SUBJECT: Transmittal of Revised Responses to AP1000 DSER Open Items

AP1000 Design Certification Review
Draft Safety Evaluation Report Open Item Non-Proprietary Responses

DSER Open Item Number: 19.1.10.1-5 (Response Revision 1)

Original RAI Number(s): 720.009, 720.012, 720.013, 720.014, 720.017, 720.021, 720.024, 720.025

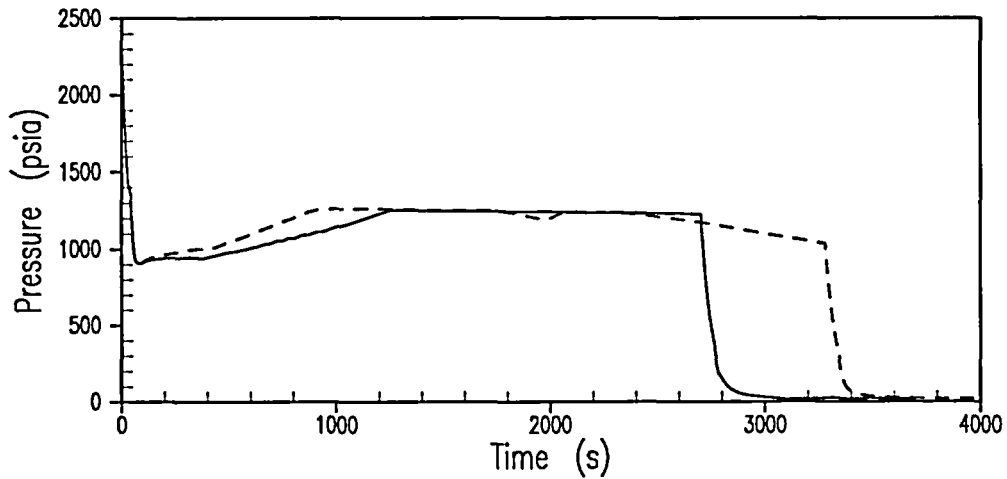
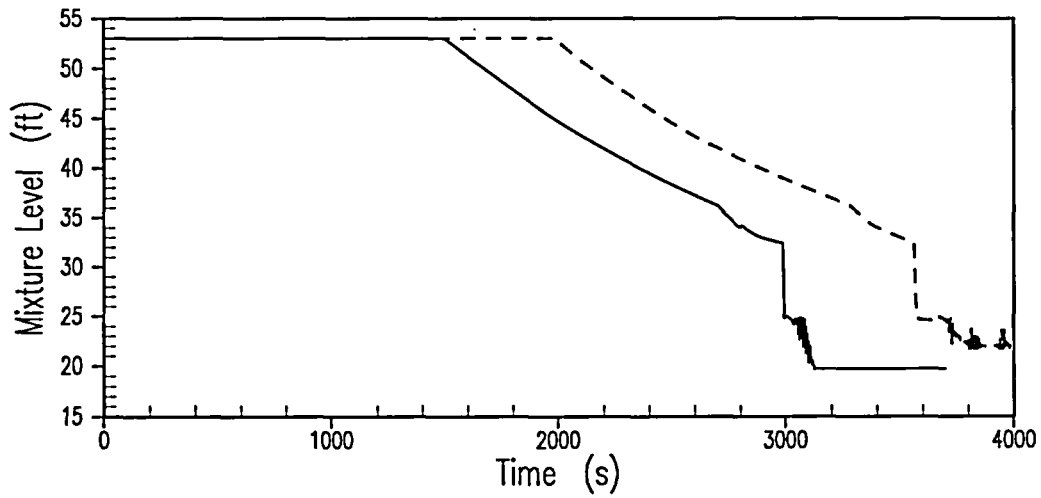
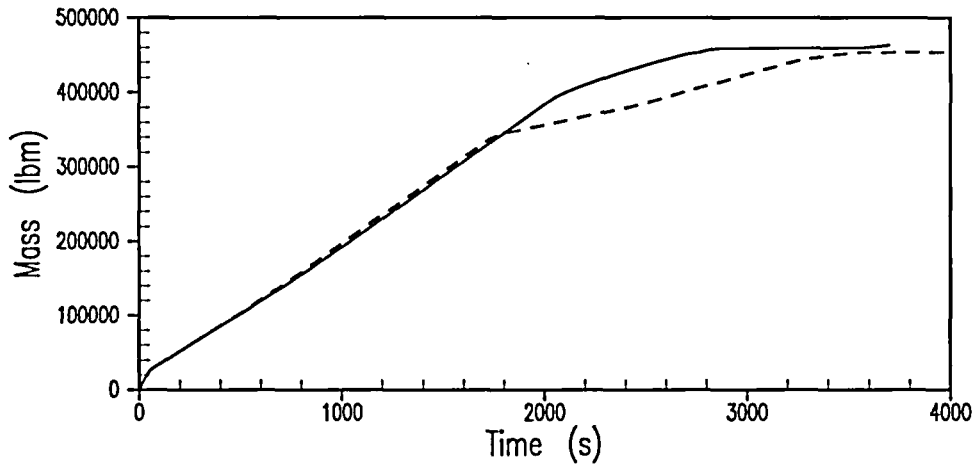
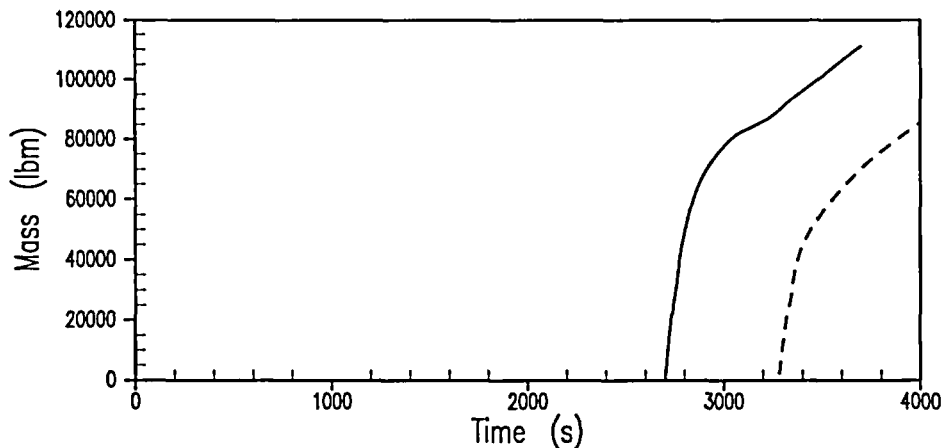
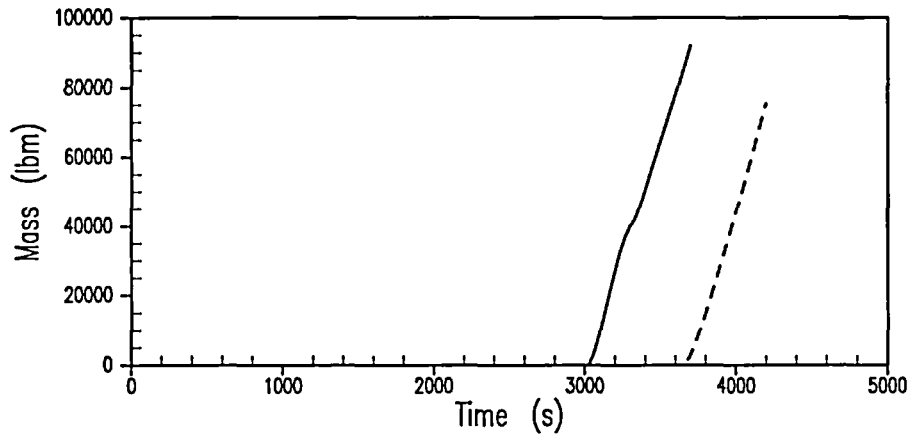
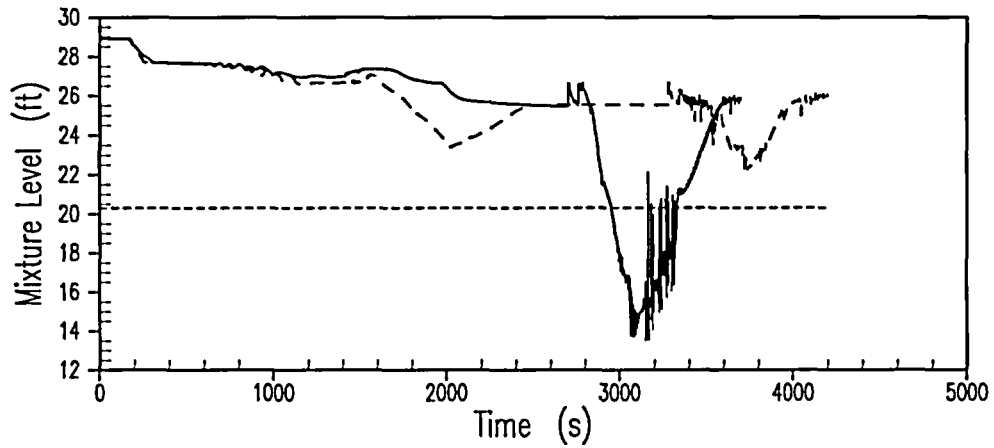
An analysis using MAAP4 was performed to demonstrate that a 30 minute delay in CMT injection is acceptable following a SBLOCA and multiple failures. The consequences were determined to be bounded by a MAAP4 analysis with automatic actuation. Westinghouse asserted that since this is not a limiting case a NOTRUMP analysis is not required. For the manual CMT case there is no ECCS for 2000 seconds after the break. For the automatic actuation case, CMT injection occurs about 200 seconds after the break. How can the automatic CMT actuation injection case be worse than the manual CMT actuation case which has a longer delay time?

- (e) The case in question (2 inch break, 1 CMT, 0 ACC, 0 ADS1-3, 0 PRHR, ¾ ADS4) has now been performed using NOTRUMP, for automatic CMT actuation and for manual CMT actuation. Comparison plots of these two NOTRUMP cases are shown in Figures 19.1.10.1-5e-1 through 19.1.10.1-5e-6. For the automatic CMT case the CMT draindown starts earlier and leads to earlier actuation of ADS4. For the automatic case the CMT recirculates from the early part of the event and its water inventory becomes heated before draindown begins, whereas for the manual case CMT draindown occurs shortly after CMT actuation and therefore is injecting subcooled liquid during its draindown. When ADS4 actuation occurs in the automatic case the vessel inventory and CMT injection are near saturation and the rapid depressurization results in sufficient voiding to cause the vessel mixture level to fall into the core region before it recovers as a result of IRWST injection. In the manual case the CMT injection just prior to and following ADS4 actuation is still highly

subcooled so the depressurization causes less voiding and the vessel mixture remains in the upper plenum region during the ADS4 to IRWST transition.

These NOTRUMP results confirm the behavior seen in the previous MAAP4 analyses.

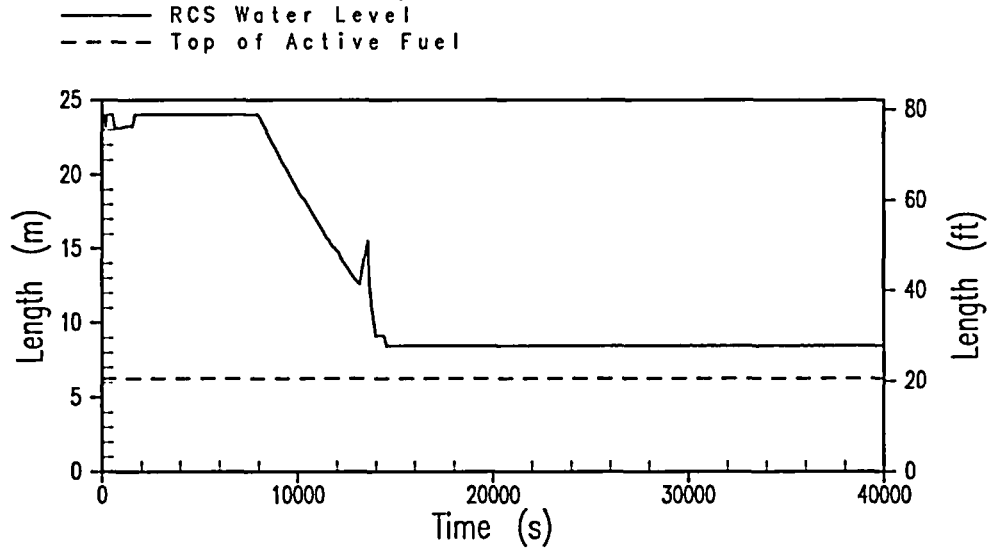
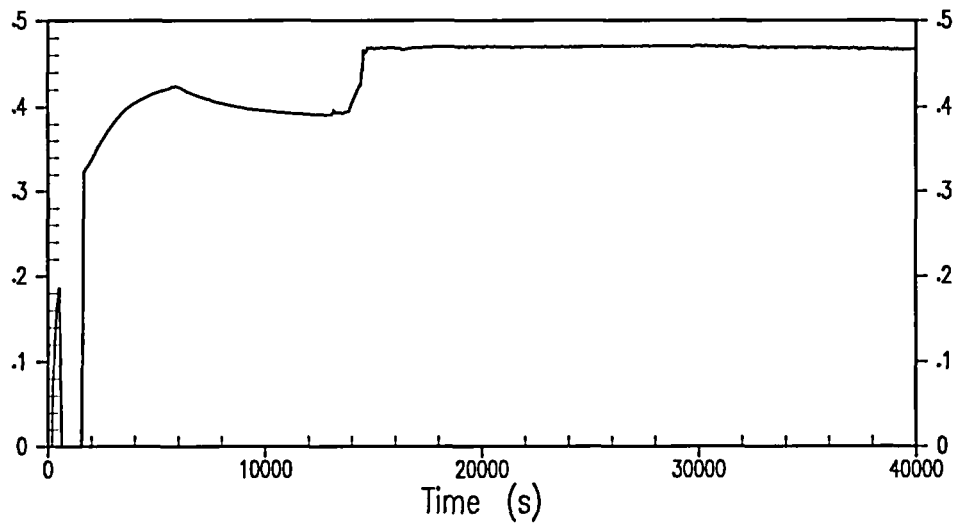
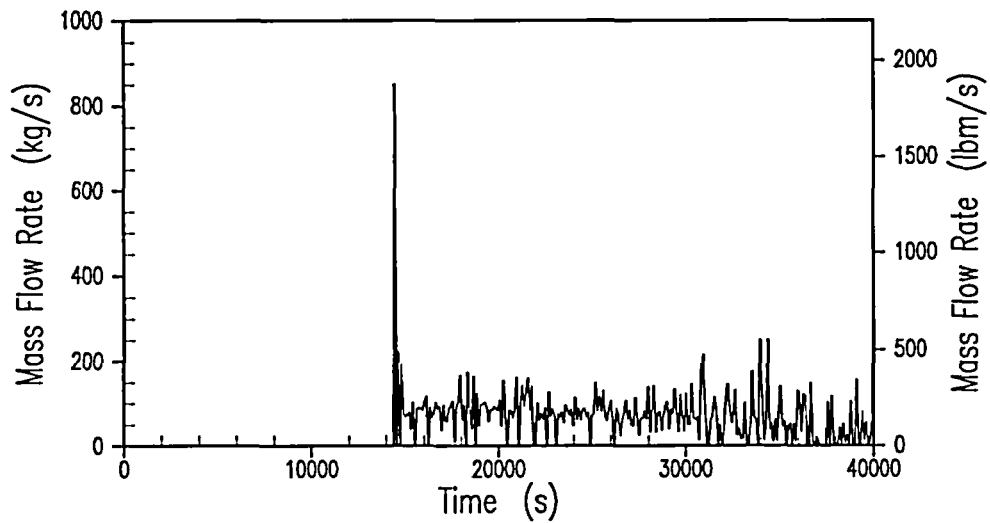
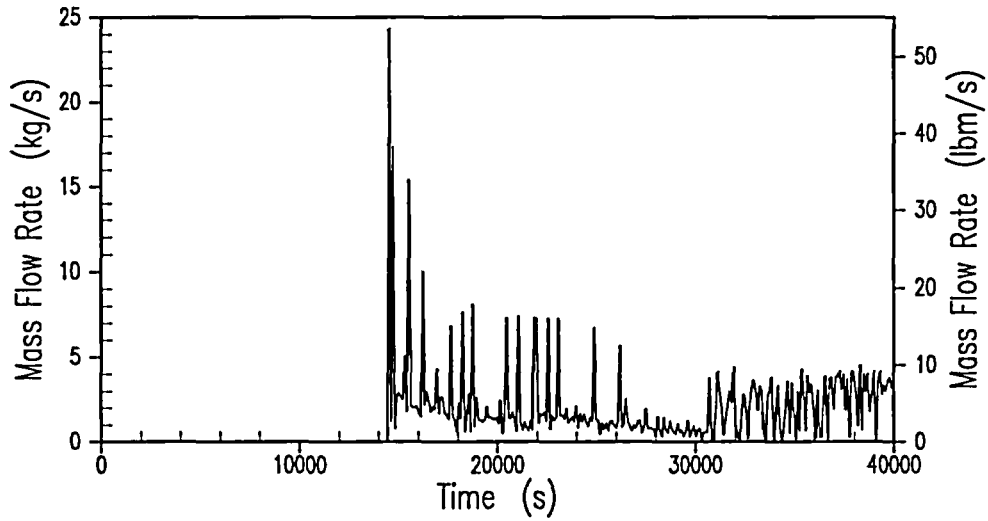
In its response to the staff RAI 440.043 regarding the AP1000 design features that mitigate or prevent steam generator safety valves challenges during an event of rupture of multiple steam generator tubes (MSGTR), Westinghouse provided a beyond-design-basis analysis of MSGTR using MAAP4. Two cases were analyzed: a passive system mitigation case with PRHR heat exchanger operation; and a minimum PRHR heat removal case with the assumption of steam generator safety valve (SGSV) failed open. Based on the MAAP4 analysis, Westinghouse concluded that for the MSGTR, the core remains covered and

cooled, and thus no significant fission product release occurs. In DSER Section 5.4.2.3.2, the staff stated that the staff's evaluation of the use of MAAP4 for the AP1000 PRA evaluation is discussed in Chapter 19 of DSER. In DSER Chapter 19 the staff gave conditions for the use of MAAP4 as described in the above excerpt.

In light of Open Item 19.1.10.1-5 and the concern described in the DSER that MAAP4 does not provide a rigorous solution of reactor system conditions during transients and accidents, the staff requests that Westinghouse confirm the beyond-design-basis MSGTR results of no core uncover described in response to RAI 440.043 with a methodology reviewed by the staff.

- (g) As discussed with the NRC in the teleconference, the use of the MAAP4 code for AP1000 is the same as was approved for AP600. Westinghouse uses MAAP4 to perform analyses of accident sequences from the PRA. For those cases with large margin (i.e. little or no core uncover), the MAAP4 results are used to validate the PRA success criteria. For low margin success sequences that are also high risk, Westinghouse performs additional analyses with the approved design basis analysis computer codes to demonstrate success.

For both AP600 and AP1000, Westinghouse has submitted results of the analysis of a multiple steam generator tube rupture. For both AP600 and AP1000, there is a large margin to core uncover, and the results have been accepted for the purpose of demonstrating the plant response to this beyond design basis accident. The previous analysis results provided for AP1000 did not identify the top of the active fuel, and the staff was unable to assess the large margin in the analysis results. The attached figures 19.1.10.1-5g-1 through 4 show the results of the multiple steam generator tube rupture for AP1000. The MAAP4 code is applied appropriately for this large margin case.
